Item 2
36 Potts Street Ryde - LDA2022/0323
Proposal: Demolition, new dual occupancy (attached) and strata subdivision

**City of Ryde
Local Planning Panel Report**

DA Number	LDA2022/0323
Site Address & Ward	36 Potts Street, Ryde East Ward
Zoning	R2 Low Density Residential
Proposal	Demolition, new dual occupancy (attached) and strata subdivision
Property Owner	Rajan Khatak & Gursimran Gill
Applicant	Rajan Khatak
Report Author	Niroshini Stephen – Senior Town Planner
Lodgement Date	17 October 2022
Cost of Works	\$1,738,077.00
No. of Submissions	Two (2) submissions received
Reason for Referral to LPP	Departure from Development Standard - <i>Development that contravenes a development standard by more than 10% (minimum frontage width).</i>
Recommendation	Approval
Attachments	Attachment 1: Draft Conditions of Consent Attachment 2: DCP Compliance Table Attachment 3: Clause 4.6 variation to Clause 4.1B Attachment 4: Architectural Plans

Figure 10 – Location of trees to be removed. Removal of Tree 1 is supported by Council's Landscape Architect

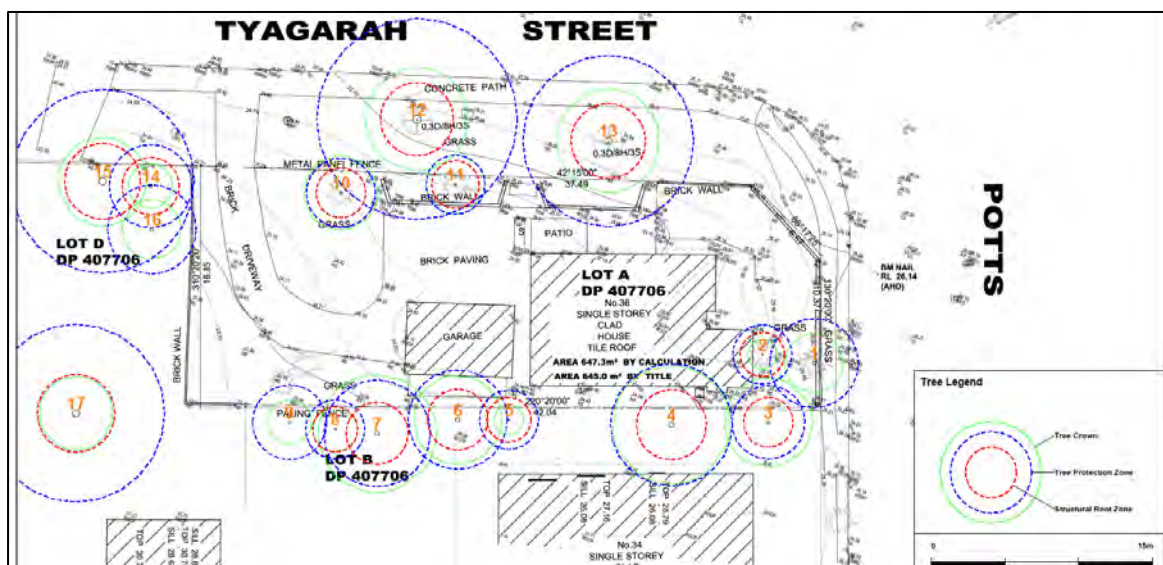
- **Single garage and single hard stand space RL 25.35** located adjacent to the south western boundary.
- **Ground Floor RL25.67:** family room, internal stairs, kitchen, laundry, bathroom and living/dining room. The living/dining room has access to the patio (RL 25.50).
- **First Floor RL28.67:** Study, bathroom, internal stairs, Bedroom 1 with ensuite, Bedroom 2, Bedroom 3 and Bedroom 4. The internal corridor has access to a balcony orientating to Tyagarah Street with a depth of 1.2 metres.
- New vehicle crossing and driveway
- Landscaping works & removal of three (3) trees as follows:

Tree No.	Species "Common name"
2	<i>Murraya paniculata</i> (Murraya)
10	<i>Plumeria sp.</i> (Frangipani)
11	<i>Plumeria sp.</i> (Frangipani)

Figure 17 – Primary road frontage notated on survey plan

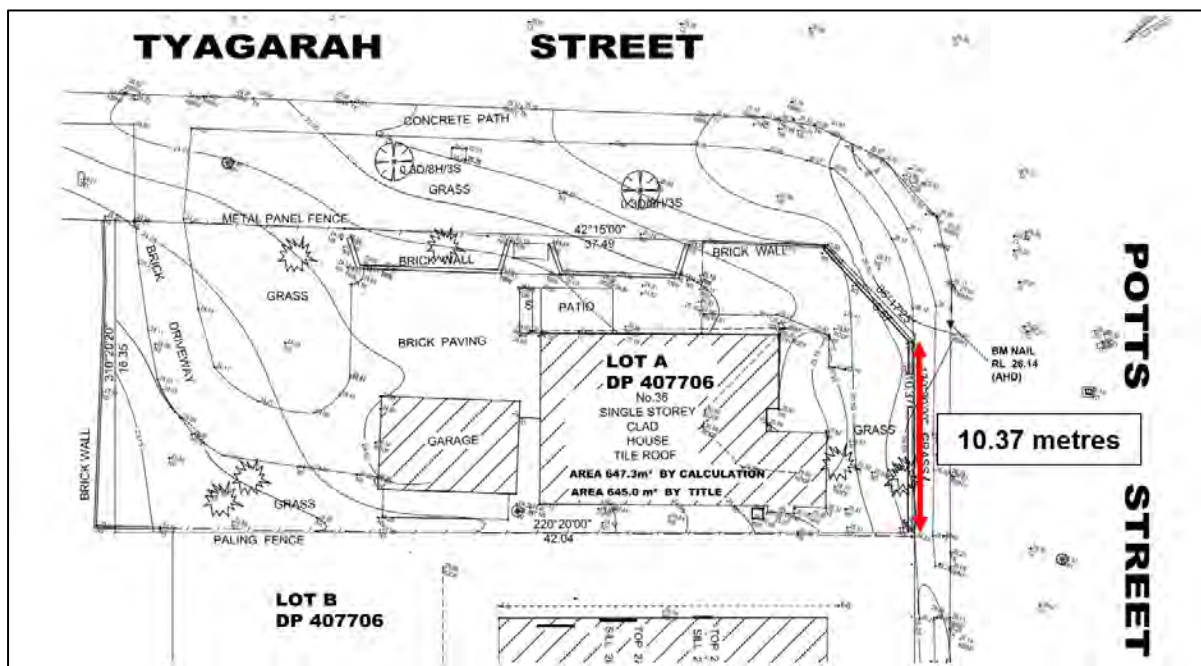
The site has a primary road frontage of 10.37 metres and does not comply with the development standard (4.1B(2)(b)) and represents a 30.87% or 4.63 metres contravention of the development standard.

Figure 18 – Width of lot measured at front setback

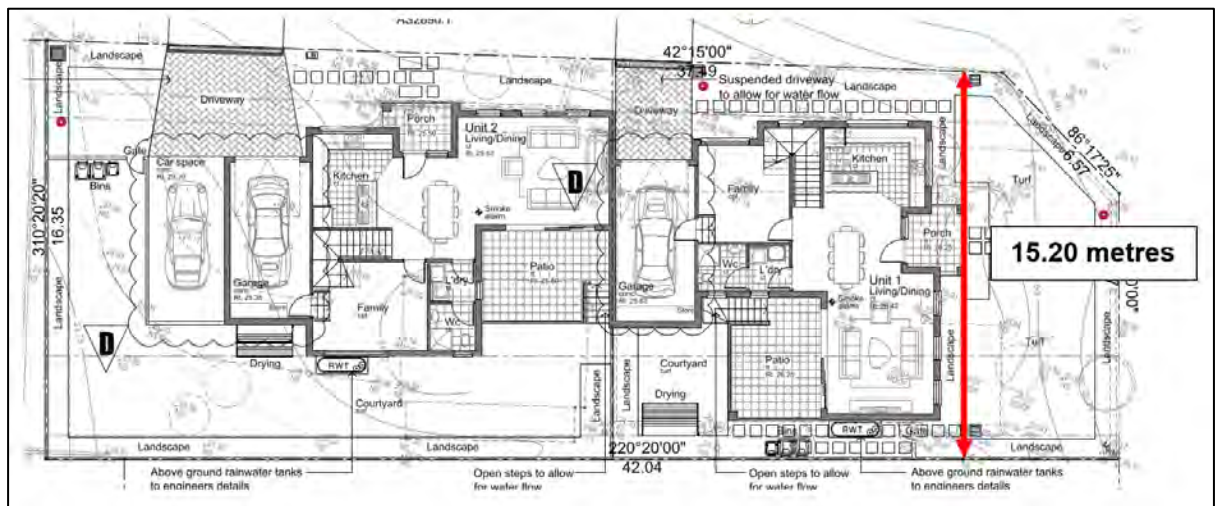
- Clause 4.1B(2) permits dual occupancy development (attached) if the area of the site is equal to or greater than 580sqm, and also has a primary road frontage of equal to or greater than 15m. This is understood to be most relevant on standard rectangular residential allotments, where there is only one road frontage and therefore the frontage needs to extend for an appropriate distance to allow two dwellings on the allotment. The subject site is a corner allotment. The corner allotment allows a design with a suitable outcome despite the 4.63 metre primary road frontage deficiency.
- Measured at the required front setback, the width of the allotment is approximately 15.20 metres which complies with the LEP requirement.

- The site is a corner allotment and has two (2) street frontages. Unit 1 orientates to Potts Street and has a frontage of 10.37 metres. Its vehicular access is provided off Tyagarah Street, with a frontage of 15.31m. Unit 2 orientates to Tyagarah Street and has a frontage of 22.175 metres.
- The proposed dual occupancy (attached) is permissible within the R2 Low Density Residential Zone. The site has an area of 647.30m². The lot size complies with Clause 4.1B(2)(a) which requires the area of the lot to be equal to or greater than 580 square metres. There is sufficient land area available for the proposed development.

Figure 19 – Rear setback notated on ground floor plan

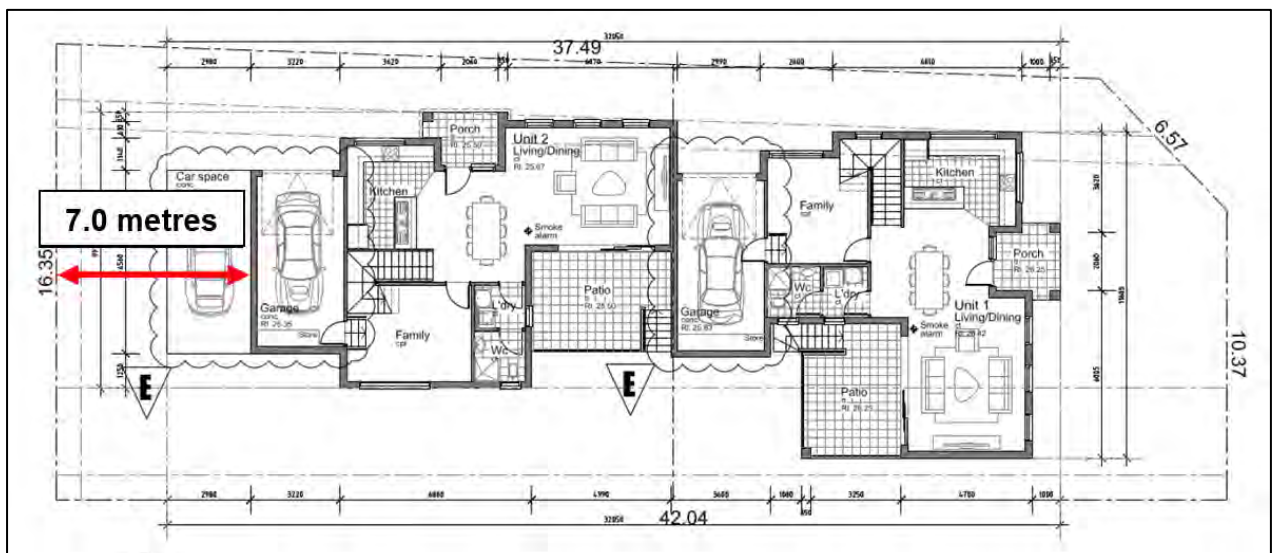
Control 2.9.3(a) states the rear of the dwelling is to be set back from the rear boundary a minimum distance of 25% of the length of the site or 8 metres, whichever is the greater. The rear setback required is 10.51 metres, being 25% of the site length. The rear setback measured to the Unit 2 garage is 7.0 metres (**Figure 19**) which does not meet the rear setback requirement of 10.51 metres. The proposal is considered acceptable for the following reasons:

- A suitable area for private outdoor recreation is provided;
- The development ensures adequate private open space for residents;
- There is sufficient area for vegetation and mature trees;
- The proposal achieves the desired spatial separation of built form between properties;
- The non compliance does not result in adverse amenity impacts to adjoining properties.

The non compliance is considered acceptable.

Figure 20 – South eastern elevation showing elevated hard stand space

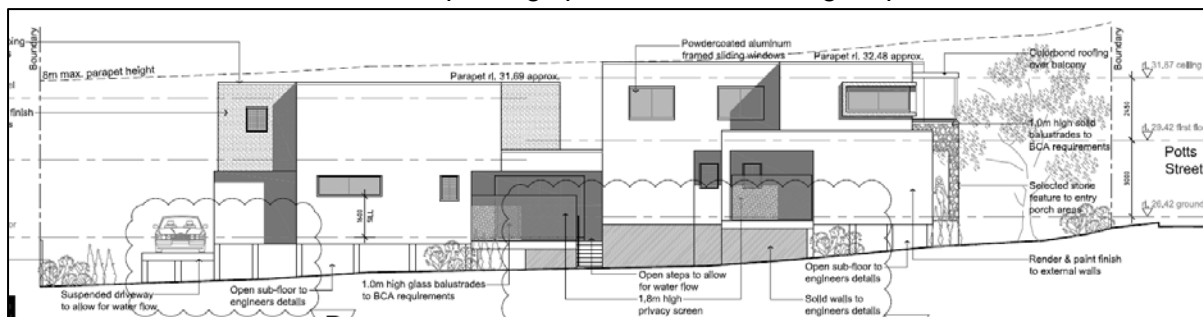
Assessing Officer comment's: The hard stand space aligns with the neighbouring properties private open space area. The proposed 1.8 metre high boundary fence and 3.0 metre high screen planting along the shared boundary will minimise light spill from the hard stand space.

The solid barrier at the end of the parking space will minimise light spill.
